WILTON PUBLIC WORKS
DEPARTMENT

MEMORANDUM

RE: 19 Cannon Rd – Baywing LLC

SUBJECT: Wilton WPCA – Sewer Capacity Review
Multi-Family Development at 19 Cannon Road
December 22, 2022 Submittal

C-1

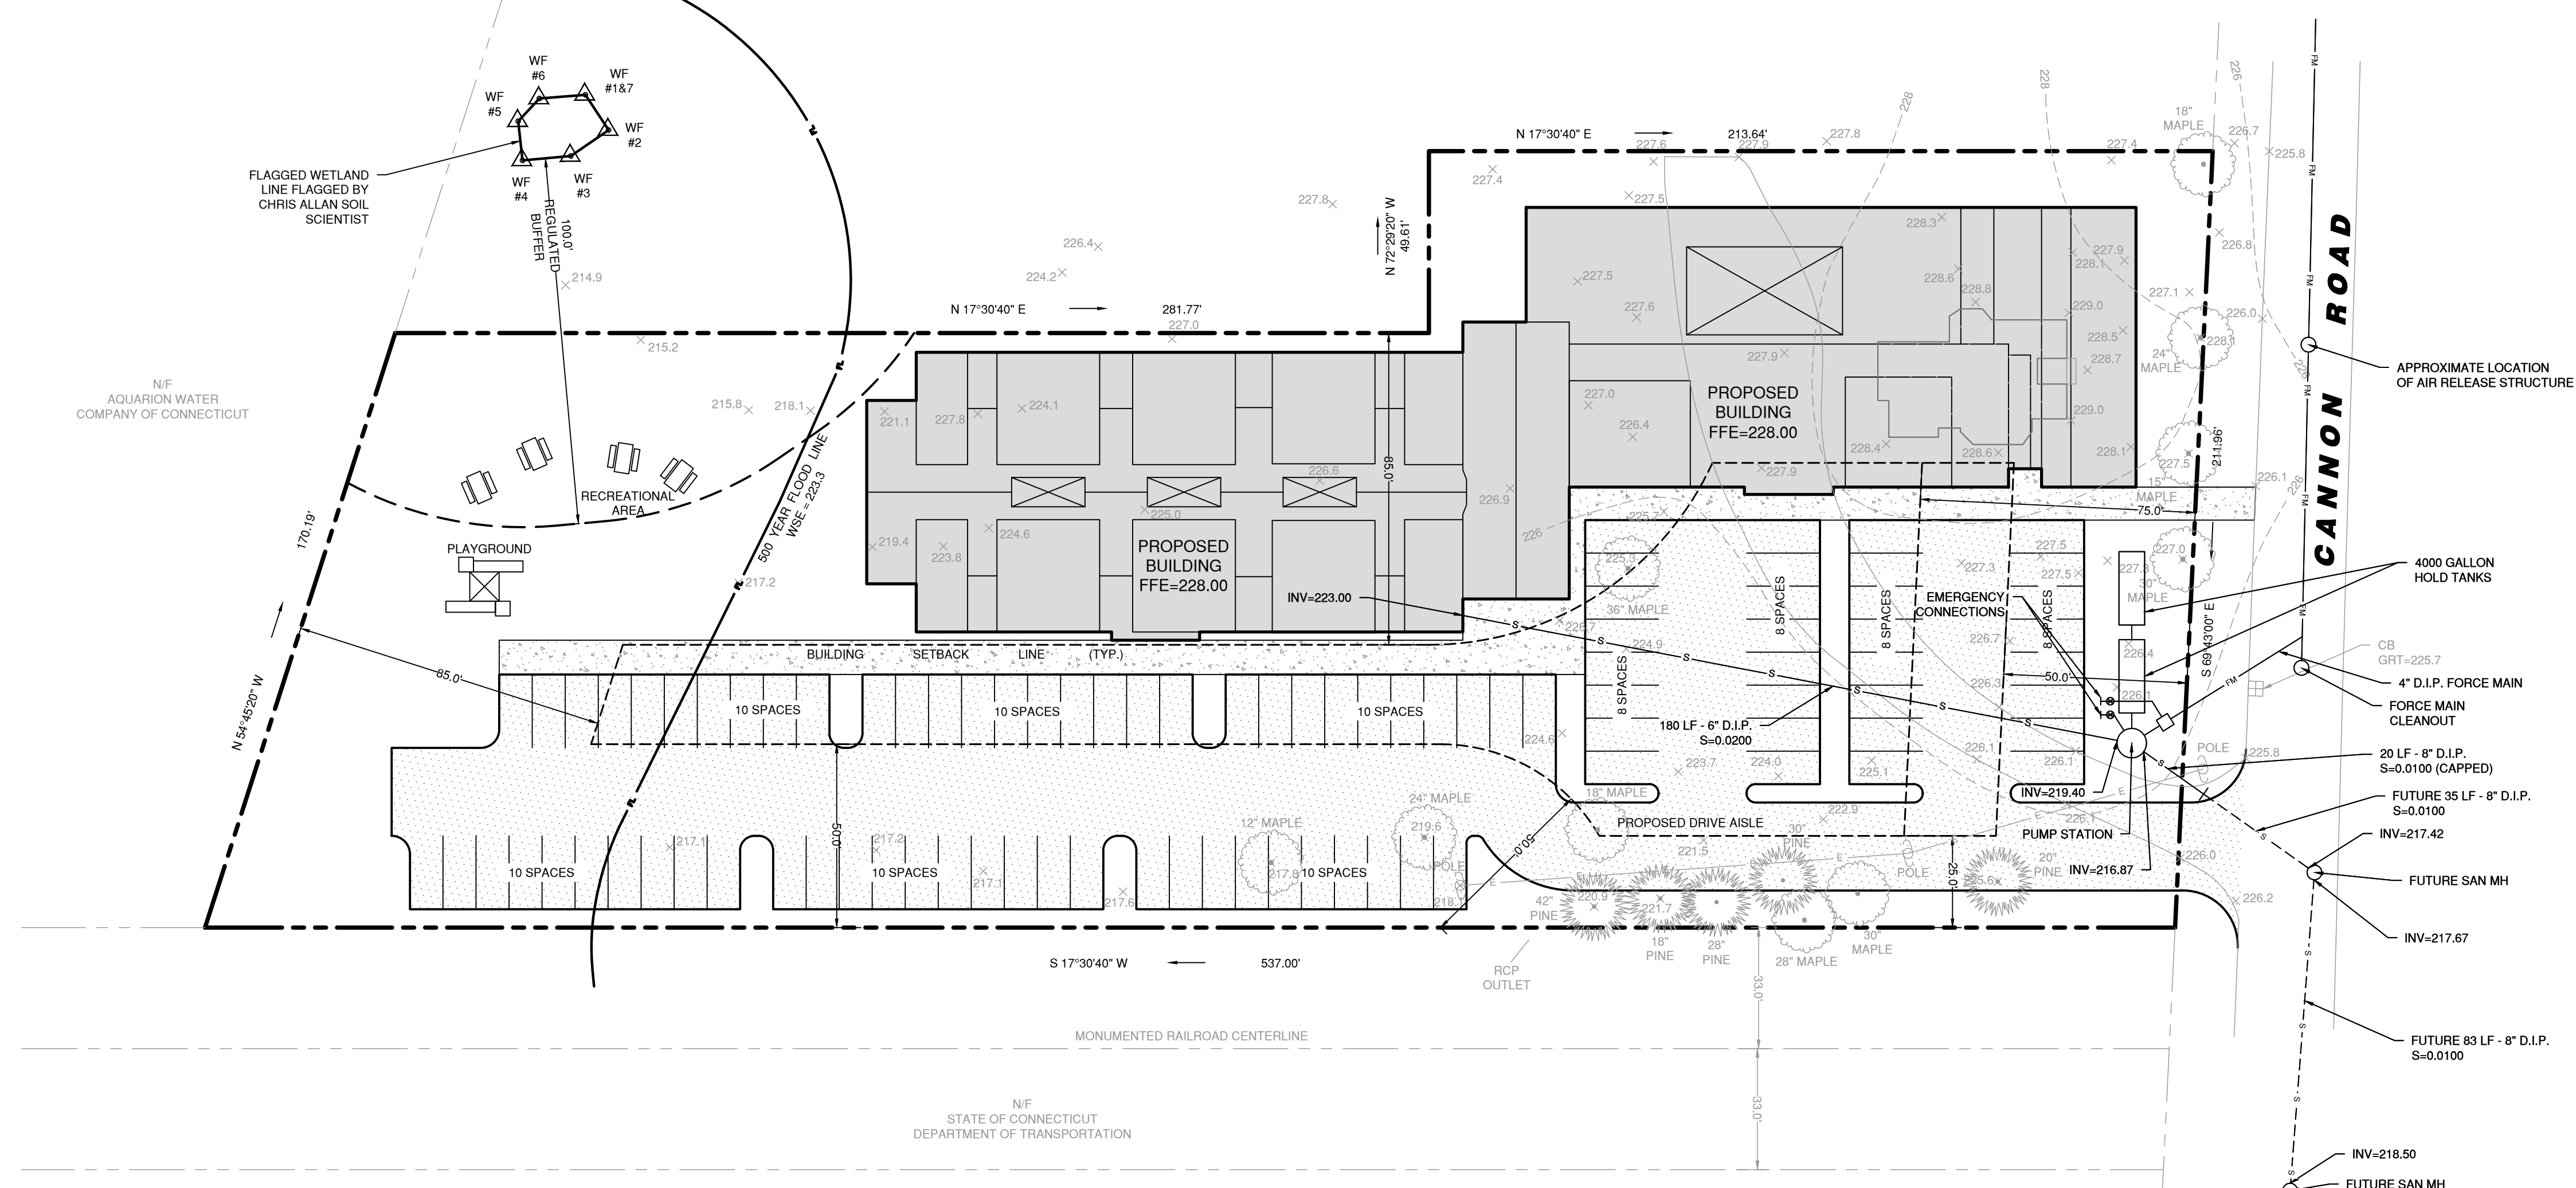
2. Revised design plans were provided. The following revisions shall be addressed at this time:
 - a. Separate generator for the pump station shall be located near the Pump Station.

- b. Separate power source shall be provided for the pump station as part of the initial installation.
 - c. Items for the pump station including, but not limited to generator, power source and pump panel, etc. shall be provided in an above ground storage building near the Pump Station. Final location and aesthetics shall be coordinated with Zoning.

- d. For safety purposes, the pump station area shall be fenced off. Landscaping shall be proposed to screen the pump station. Location of fence shall be coordinated with zoning.

- e. Portable pump connections shall be relocated.
 - f. Elevation of Force main along Cannon Road shall be revised to eliminate the low point. The slope of the force main shall be pitched downward from Route 7 to pump station to eliminate the air relief valve.

- g. The force main along Cannon Road shall have the proper separation distance from the water main.
 - h. Please note, the proposed new pump station at 19 Cannon has been lowered to receive sewer flow from potentially another future development. If the Town approves any additional flow into this pump station, the pump station at 19 Cannon Road would have to become Town-owned. The condition of the pump station would have to be evaluated and repaired by owner at 19 Cannon Road prior to turn over and any upgrades would have to be performed by the new potential developer. Agreement defining terms will have to be created at this time.

The portable pump connections are oriented towards the parking lot. If there are vehicles utilizing the parking spots along the pump station it will hinder access to the portable pump connections, likely needed during an emergency condition. Please review and revise the pump connections (suction and discharge) based on where a portable pump, truck, or other maintenance equipment could be located while under emergency operations, when required.

The force main should be installed at a constant pitch upwards toward the discharge into the gravity sewer. Installation of the force main with a constant pitch upward should eliminate the low spot under the existing storm drain near station 2+00 which could become a clogging concern. The upward slope will also eliminate the need to install the air release valve and structure which removes another long-term maintenance requirement.

The Connecticut Department of Public Health Drink Water Section's "Water Main Design and Construction Guidelines" document requires that water and sewer force main have a minimum 10-foot separation distance. The revised plan appears to show less than this separation for its entire length. The force main route on Cannon Road should be adjusted accordingly and/or provide other means of protecting the water main (i.e., encasement).

1. Elevations are shown for the potential future extension to the adjacent property that may be serviced by the proposed station in the future. The plan note mentions that some of the information was taken from the 2011 plans for the development for that parcel. For documentation purposes, if there were any additional design assumptions made as part of the design of this proposed station, provide a summary of the design concept behind the elevations and location of the future pipes and their impact to the pump station.

5. There is no size listed on the piping for the cleanout assembly for the force main. It is assumed it will be the full size of the main; please clarify.

6. Please review and revise the trapped drain from the valve vault to the wet well. We have a few concerns with this installation:
 - a. With the requested change to the piping elevations, the vault will likely get deeper as well. Please indicate the elevation of the vault floor (as opposed to minimum depths).

- b. The elevation of the drain connection to the wet well is below the elevation back to the holding tank, therefore the valve vault or the drain's trap could potentially be filling with sewage during emergency conditions.

- c. Is this drain needed? It is assumed that this drain is intended for any rainwater leakage from the hatch or groundwater leakage into the chamber. Could these simply be pumped out on a regular basis, instead of connecting the structures?
